UNITED STATES PATENT AND TRADEMARK OFFICE

APPLICATION NO.	FILING DATE	FIRST NAMED INVENTOR	ATTORNEY DOCKET NO.	CONFIRMATION NO.
10/686,480	10/16/2003	Katsunori Nishimura	520.43216X00	8057
20457 7590 05/18/2009 ANTONELLI, TERRY, STOUT & KRAUS, LLP 1300 NORTH SEVENTEENTH STREET SUITE 1800 ARLINGTON, VA 22209-3873				
EXAMINER CHUO, TONY SHENG HSIANG				
ART UNIT 1795		PAPER NUMBER		
MAIL DATE 05/18/2009		DELIVERY MODE PAPER

DETAILED ACTION

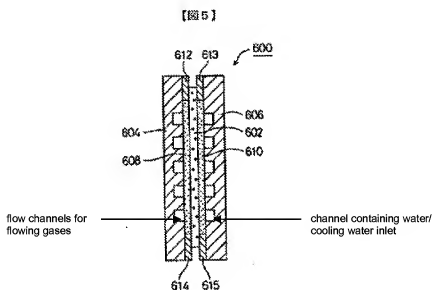
Regarding claims 33 and 46, the Kawazu reference discloses a fuel cell assembly comprising: a humidifier "200" and a plurality of fuel cell units "10", wherein each of the fuel cell units comprises an electrolyte membrane "11", a cathode "12" adjacent to one face of the membrane, an anode "13" adjacent to the other face of the membrane, a gas diffusion layer adjacent to the cathode, a gas diffusion layer adjacent to the anode, a separator "14" having a flow channel for flowing oxidizing gas, which is adjacent to the cathode, and a separator "15" having a flow channel for flowing fuel gas, which is adjacent to the anode, wherein the humidifier comprises a porous membrane "602" (porous water-retaining layer) for retaining water supplied thereto, wherein the porous membrane "602" communicates with a channel containing water (not labeled) by way of a porous carbon (filter) "610" for passing water, but not gas, the channel containing water exclusively supplying water to the porous membrane, supplying water thereto via the filter, wherein the porous carbon (filter) is disposed at a position where the cooling water inlet and the porous membrane communicate with each other, and wherein the humidifier adjoins an end of the plurality of the fuel cell units in such as relation that the porous membrane faces the flow channels thereby to transfer water introduced into the porous membrane to the fuel gas and oxidizing gas flowing in the flow channels, the flow channels for flowing gases being partitioned with a wall "612",

"608", "614" from the channel containing water (See paragraphs [0031],[0033],[0034],[0036],[0040], and Drawings 1, 3, and 5). It also discloses a porous membrane that is a hydrophilic polyolefin material (See paragraph [0037]). It also discloses a porous membrane "602" that takes water therein at a peripheral portion thereof, where the porous membrane is in contact with cooling water (See Drawing 5).

In response, the examiner disagrees because the Kawazu '704 does disclose a porous membrane "602" (porous water-retaining layer) that is in communication with a channel containing water by way of a porous carbon (filter) for passing water, but not gas, this water channel exclusively supplying water to the porous membrane, supplying water thereto via the porous carbon (filter) (See Drawing 5 above).
